TECHNICAL NOTE

Date:	03/09/2020	Ref:	402.06594.00008 - TN02 v01
Subject:	Middleton Development – Discharge of Surface Water Drainage Conditions Prepared for: Frontier Estates Ltd

Drawing Title: **PROPOSED DRAINAGE LAYOUT**

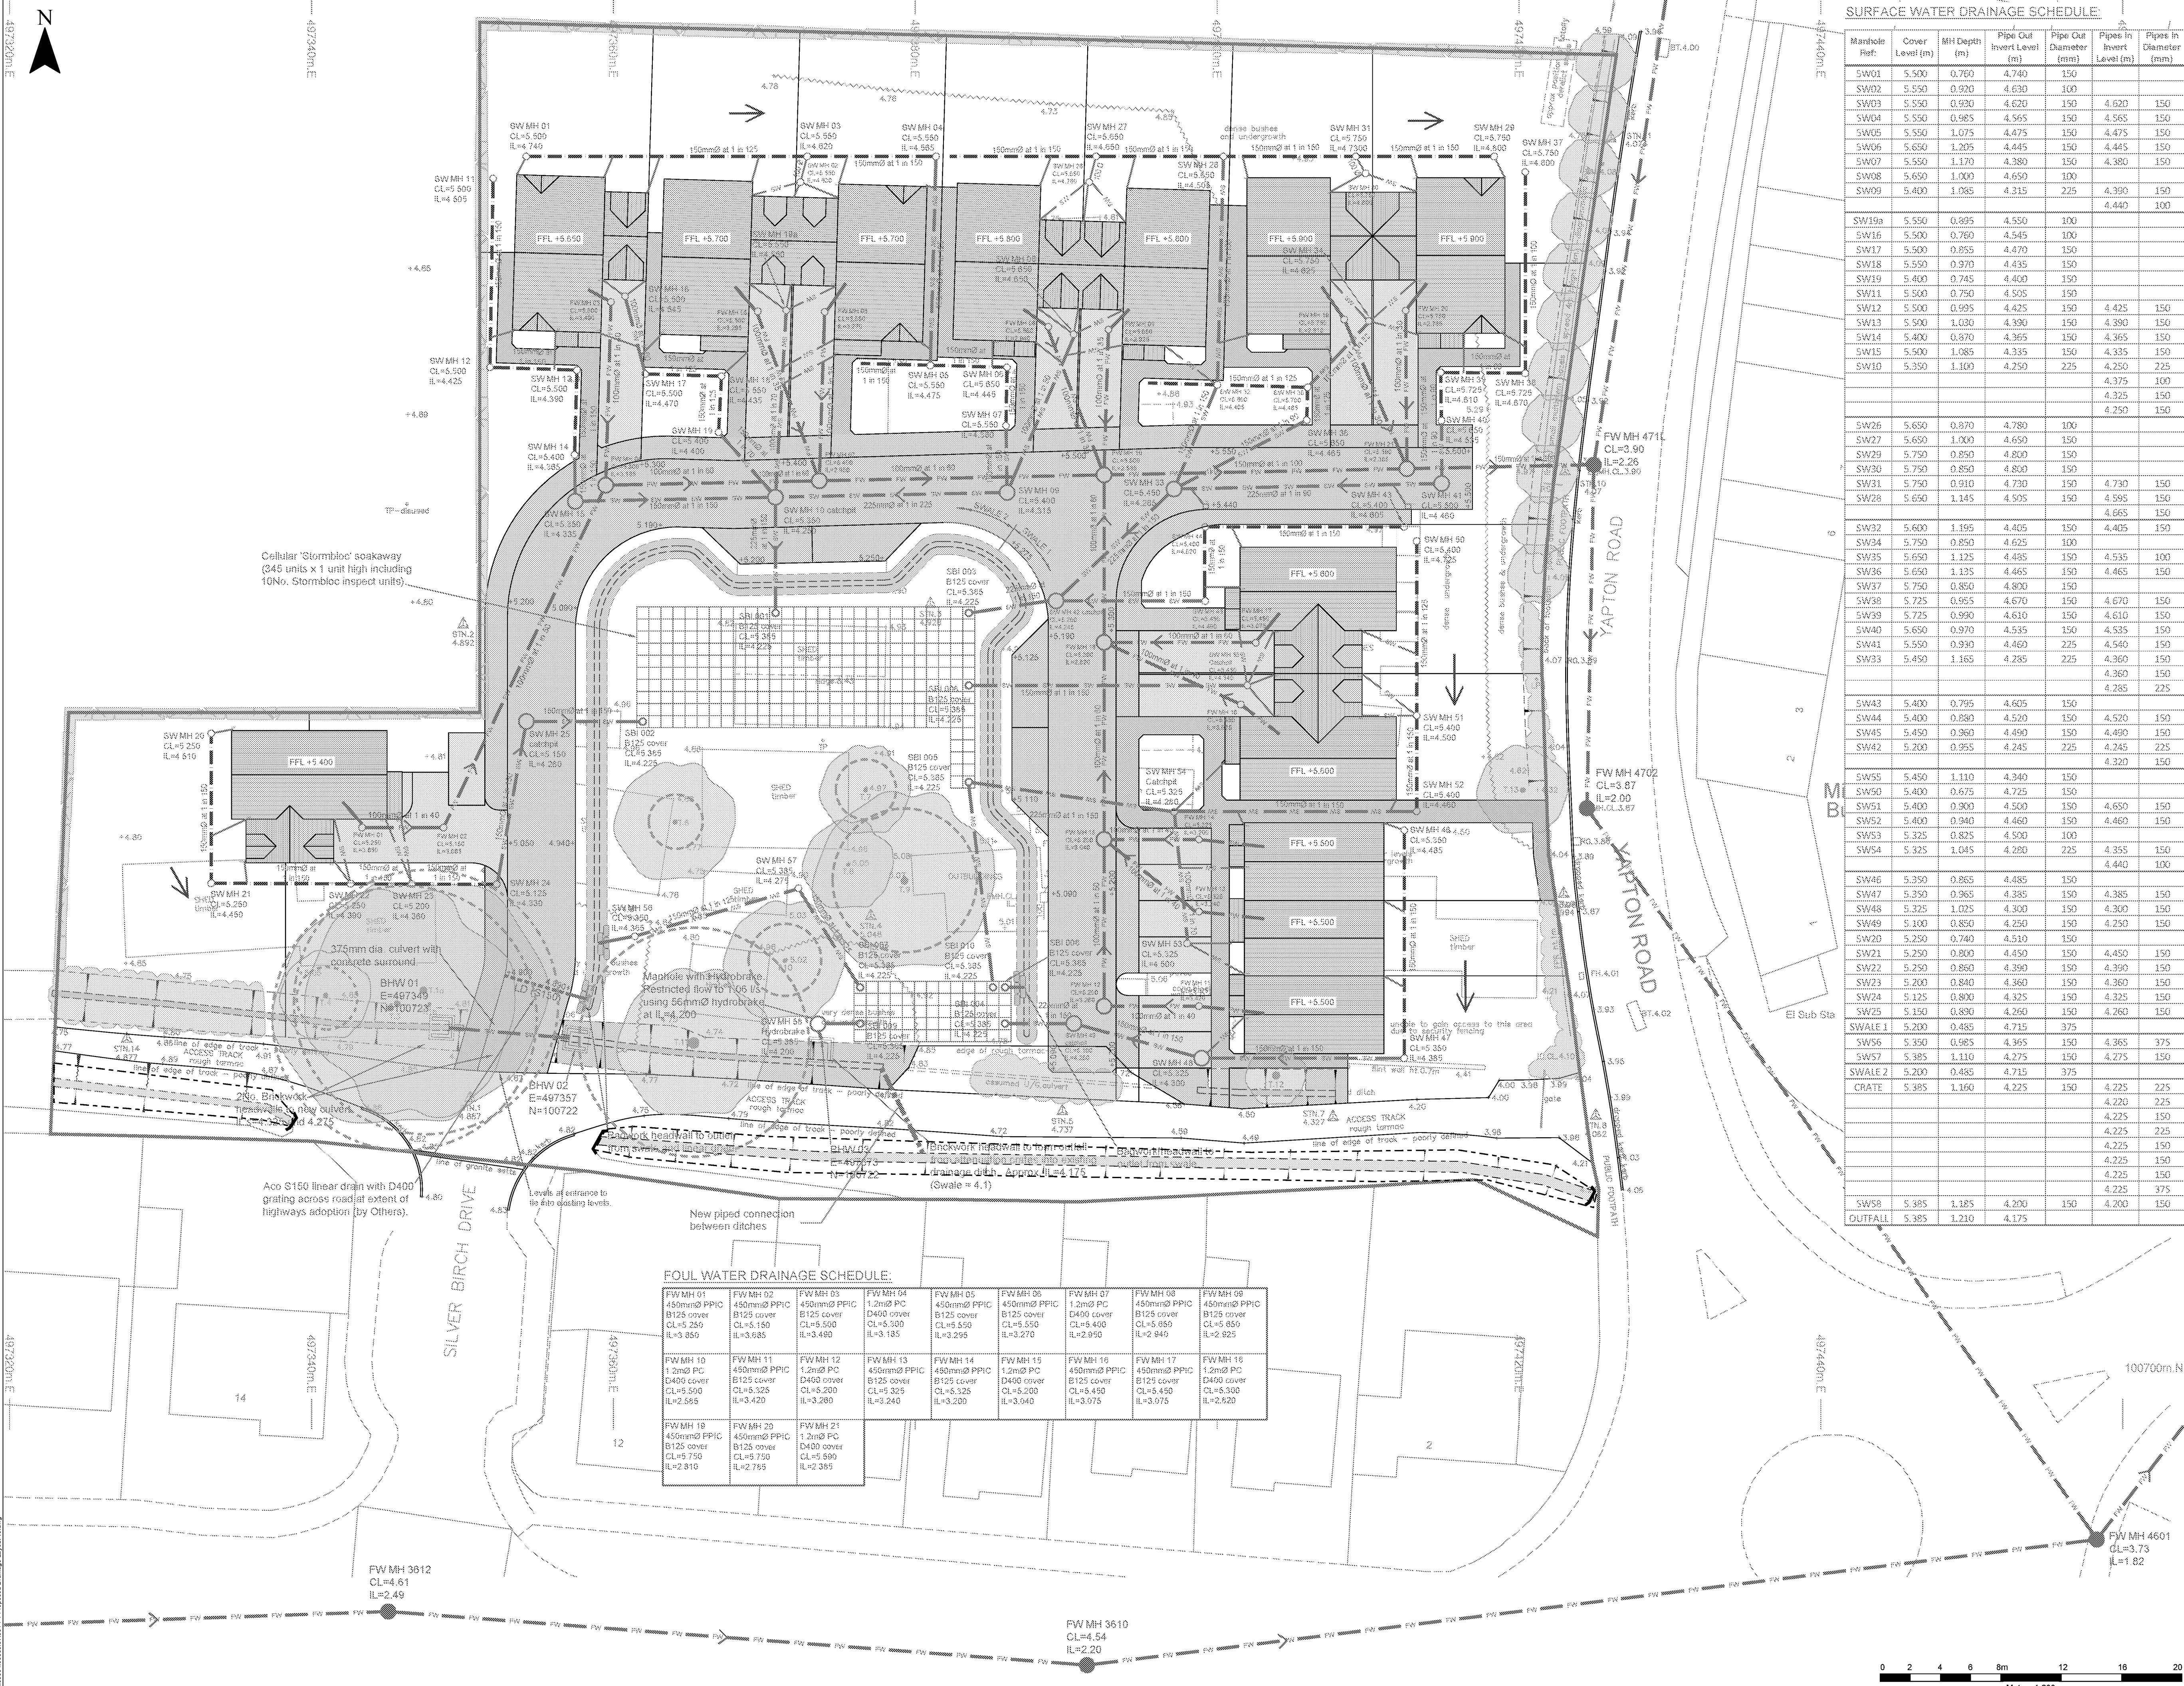
3. Please provide an impermeable areas plan to facilitate review.
4. Manhole schedule makes paperless review difficult. Please detail cover and invert levels on plan at manholes.

5. Details to be reviewed in greater detail at later stage, invert level of outlet to ditch appears low, can this be raised.
6. Attenuation crates, labelled as soakaway, please amend.

7. Please provide invert levels on hydrobrake detail, as well as specific hydrobrake reference, step rungs, bypass arrangement.
8. Please provide levels on swale, confirm if sufficient cover is provided where swale overruns crates.

9. Sumps will be required at the downstream ends of the swales, before connection into crates.
10. Please include root protection zones on plan.
11. Please include a construction detail of root barrier around tank.

The drainage detailed design has been supplemented with a highway design that has allowed finished formation levels to be set out for the site. These levels are now shown on 402.06594.00008.001 P1 Proposed Drainage Layout shown in **Appendix 01**.

The southern ditch outfall level has been reviewed and accepted (outfall IL 4.175m AOD and ditch IL 4.100m AOD) as part of the latest drainage detailed design. The arrangement is shown on 402.06594.00008.001 P1 Proposed Drainage Layout shown in **Appendix 01**.

The road gradients have been set with a slope towards the swale that runs unobstructed around the centre of the site; this then enters the centrally located crate storage system via gullies. A manhole schedule has been provided on the strategy drawing in **Appendix 01** together with swale, cover and invert levels shown on the drawing.
